Service Bulletin

Bulletin No.: PIP5072

Subject: Slip In Forward Ranges Immediately After Replacing The Input Housing - 621 - Check Input Housing - 621 - For Improperly Drilled Feed Holes

2966700

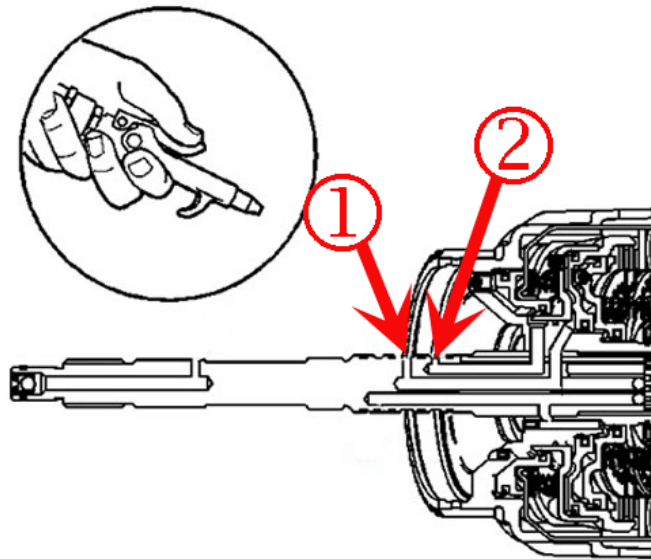
The Input Housing (621) from GM Service Parts may have an incorrectly drilled input shaft.

Air leaking from 3-4 apply hole may be noted when applying air pressure to the forward clutch apply hole during an air check with the Input Housing (621) fully assembled with seals and clutches.

Inspect the 3-4 clutch and the forward clutch oil feed passages for leakage between circuits. Apply regulated compressed air to the 3-4 clutch feed hole and the forward clutch feed hole one at a time with the Input Housing (621) completely assembled. See picture below.

Air should not leak out of the 3-4 clutch feed hole when applying air to the forward clutch feed hole and air should not leak out of the forward clutch feed hole when applying air to the 3-4 clutch feed hole. If air leakage is noted between the two feed holes the Input Housing (621) should be replaced with one from GM Service Parts. (Order new housing part number 19125752.)

Call out 1: Forward clutch feed hole.

Call out 2: 3-4 clutch feed hole.

Do not replace an Input Housing (621) assembly solely because of a small air leak between the shaft and housing. Re-use or replace the part based on results of inspection as described in Input Housing and Shaft Assembly Inspection above.
